Janet Ray Answers to Detroit Historic Commission (June 15, 2022 email)

For: 1402 Vinewood, Detroit, MI 48216

Request: Remove a vertical slider window and replace with vinyl siding to match the rest of the house.

Date: July 1, 2022

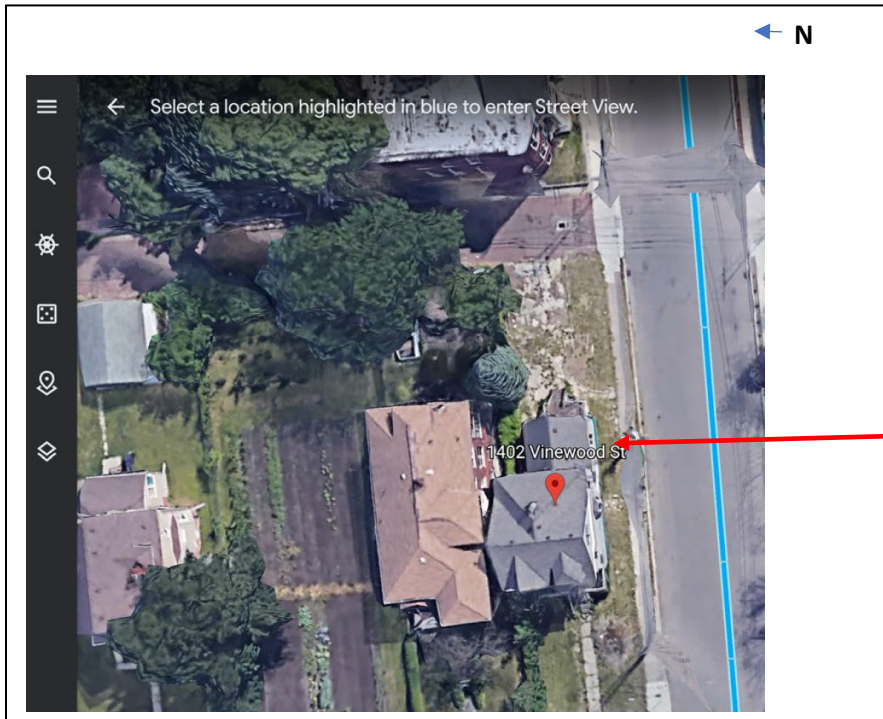
- 1. Please provide a detailed image of the existing siding to show what is existing, and an image of the siding you are replacing it with. What is the material of the replacement siding?**

- 2. We need to know what the existing material is of siding. Wood- aluminum – vinyl?**

- 3. Also note the size of existing exposure and size of replacement exposure. This means the size of the area between horizontal boards.**

- the location, quantity and size of any exterior item that is proposed to be repaired, replaced, removed, built or installed – DESCRIBE SIDING YOU WILL BE INSTALLING AND PROVIDE INFORMATION FROM MANUFACTURER ABOUT PROPOSED SIDING – PHOTO WITH COLOR, SIZE AND MATERIAL

Answer: The replacement material is vinyl. It is the same color and size of the rest of the house. The replacement vinyl siding will be purchased from Eastern Michigan Distributors. It is the SC Clapboard – D4 Pebble Clay. It match the existing vinyl siding.

This is the South facing window to be removed. The opening will be closed with the same vinyl siding that is current on the house.

Answer: The existing material is vinyl.

Answer: The opening size of the vertical window to be removed is 48 inch in height by 36 in in width.

The replacement siding will be purchased from Eastern Michigan Distributors. It is the SC Clapboard – D4 Pebble Clay. It matches the existing siding.

Top View from google earth of the lot This shows the location of the window I want to remove. Before I purchased the house, an addition was put on the house and previous owners put in a vertical window in.
